TO: Mercedes-Benz Dealer Principals, General Managers,	FROM: Gregory Gunther, Department Manager, Vehicle	
Sales Managers, Service Managers, Parts Managers	Compliance and Analysis, Engineering Services	
RE: Recall Campaign Launch Notification		
Install 12 Volt Battery Support	DATE: December 21 2022	
MY19-22 CLS-Class and E-Class	DATE: December 21, 2022	
(257 and 213 platform)

Campaign No. 2022100009, December 2022

SUBJECT: Model CLS-Class and E-Class (257 and 213 platform) Model Year 2019-2022

Install 12 Volt Battery Support

Retrofit battery support in spare wheel well

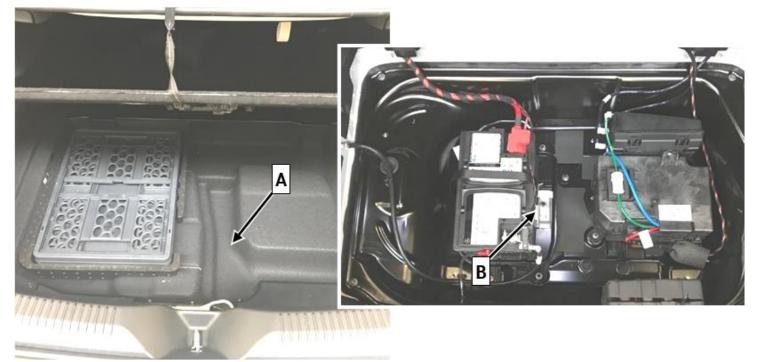
Mercedes-Benz AG ("MBAG"), the manufacturer of Mercedes-Benz vehicles, has determined that on certain MY19-22 CLS-Class and E-Class (257 and 213 platform) vehicles, the 12V battery in the trunk might be dislodged in the event of a crash and subsequently detach from its electrical connections. This, in-turn, may lead to impairment of post-crash functions such as eCall, electric seat adjustment, hazard warning lights, and automatic door unlocking, which could increase the risk of injury for the vehicle occupants. An authorized Mercedes-Benz dealer will install additional mounting support for the 12V battery on the affected vehicles.

i For Model W 213.0, 213.1 and 257, see Work Procedure A.

i For Model S 213.2, see Work Procedure B & C (if applicable).

Figure 1

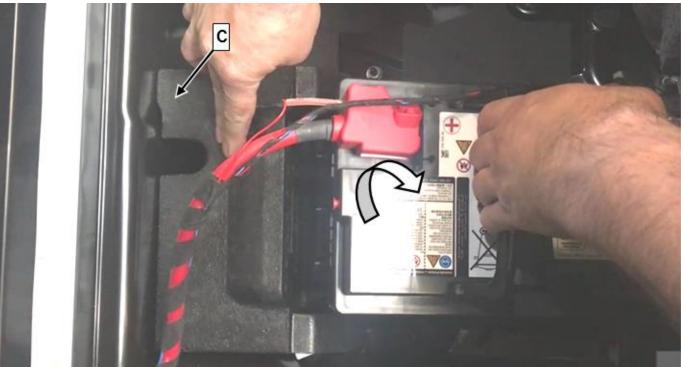
- **1.** Lift trunk cover.
- 2. Fold felt trim (A, Figure 1) above battery upward.

- 4. Unscrew screw of Battery attachment (B, Figure 1).
- 5. <u>Tilt</u> battery slightly and insert battery support (C, Figures 3 and 4).
 - i Mount battery such that it is in full contact with support.
 - i Battery is tilted slightly opposite to the direction of travel with lines connected.
 - Me Screw/nut holder/retaining bracket for battery on battery frame 23 Nm
 - 1 The edges of the battery support are in contact around the battery and in the battery base.

Figure 5

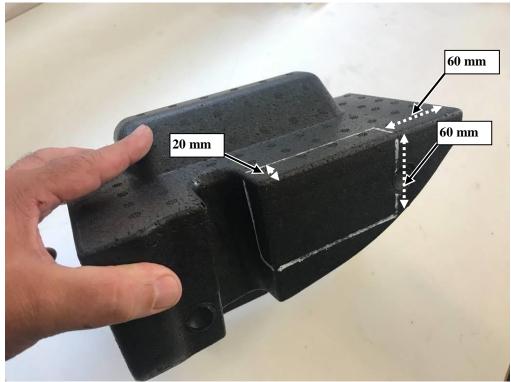
i Adaptation of battery support due to spare wheel well with opening and cap.

1. Cut out battery support as shown.
